**TO:** Development Review Board  
**FROM:** Scott Gustin *SG*  
**DATE:** April 15, 2014  
**RE:** 14-0799CA; 203 South Willard Street

**Request:** Amendment to zoning permit #14-0383CA/CU to include reuse of existing rear addition on West side of structure, changes to west elevation, and removal of two rear chimneys.

Chimneys  
Removal

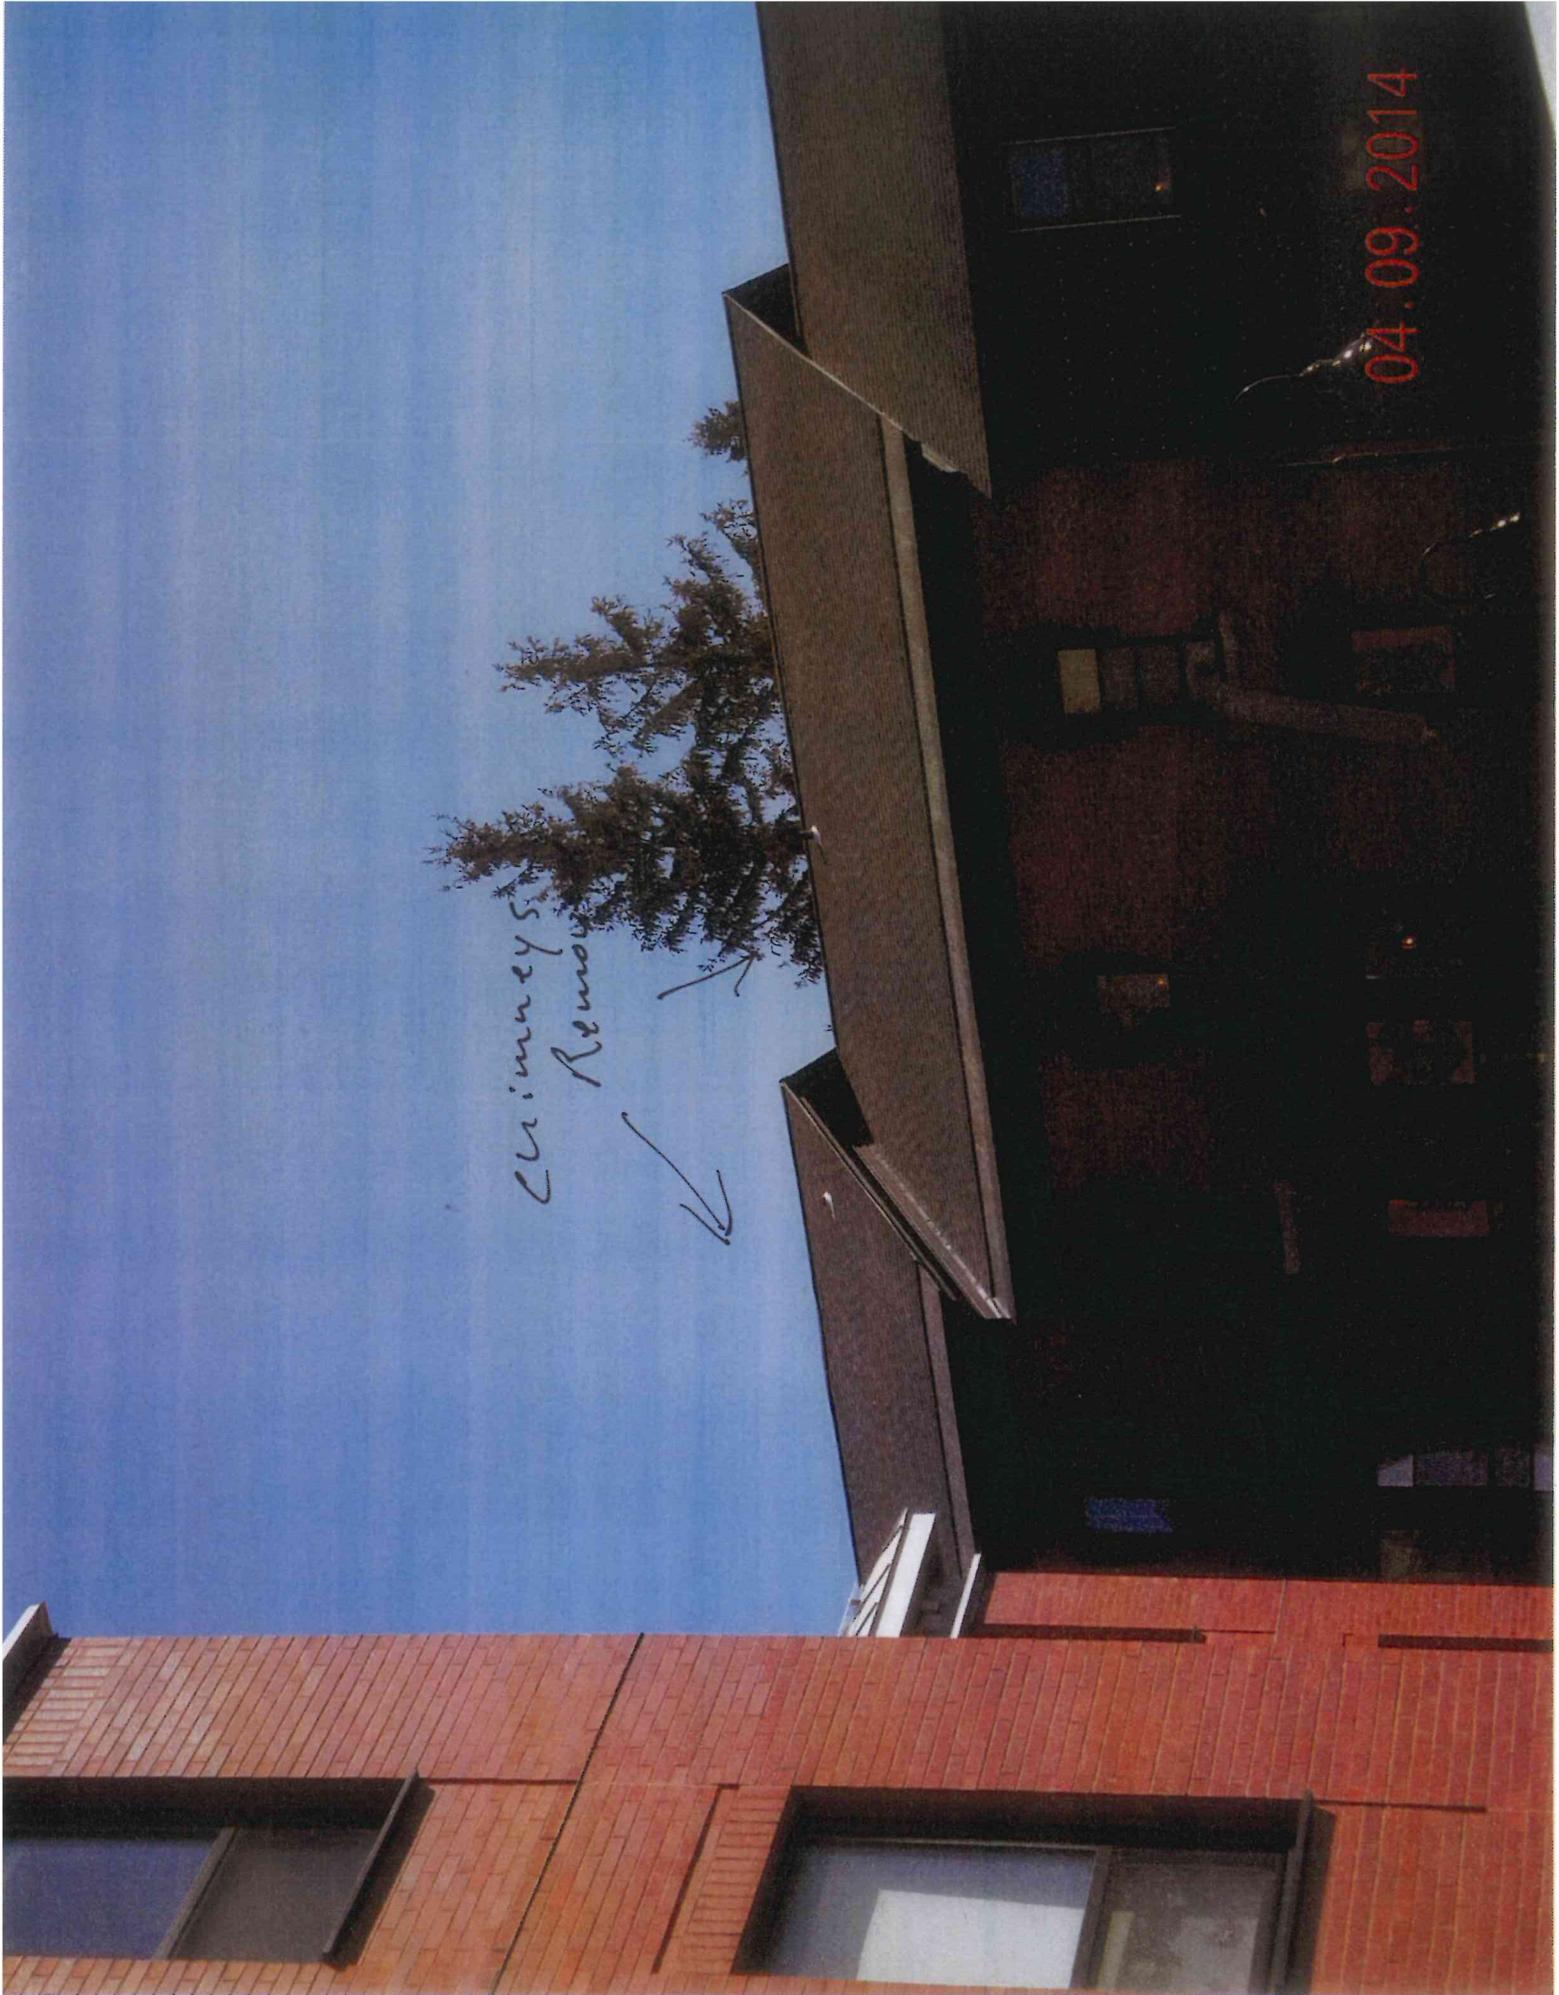
The proposed amendment also seeks to remove two of three brick chimneys from the original portions of Whiting Hall. This request is problematic as it seeks to remove character-defining elements from this National Historic Register structure. Further, as confirmed by a visit to the site on April 9, 2014, the chimneys have been removed without a zoning permit.

Whiting Hall is an impressive Italianate brick structure with elaborate wood detailing and redstone foundation. It has three rooftop brick chimneys. Much of the building's original integrity has been retained. The original slate roofing, however, has long ago been replaced by asphalt shingles. The removal of two of the three brick chimneys constitutes a further erosion of the historic integrity of this building. The removal is inconsistent with the intent of this criterion to avoid the removal or alteration of features that characterize a property. The chimneys must be replaced. **(Adverse finding)**

Two of the three brick chimneys on this building, a common defining feature of historic buildings in Burlington, have been removed. Doing so runs contrary to the intent of this criterion that seeks to preserve and retain such features. **(Adverse finding)**

1. This approval is limited to the changes and addition to the existing rear addition of Whiting Hall. It does not include removal of the two brick chimneys. These chimneys shall be replaced within 3 months of the date of this approval.
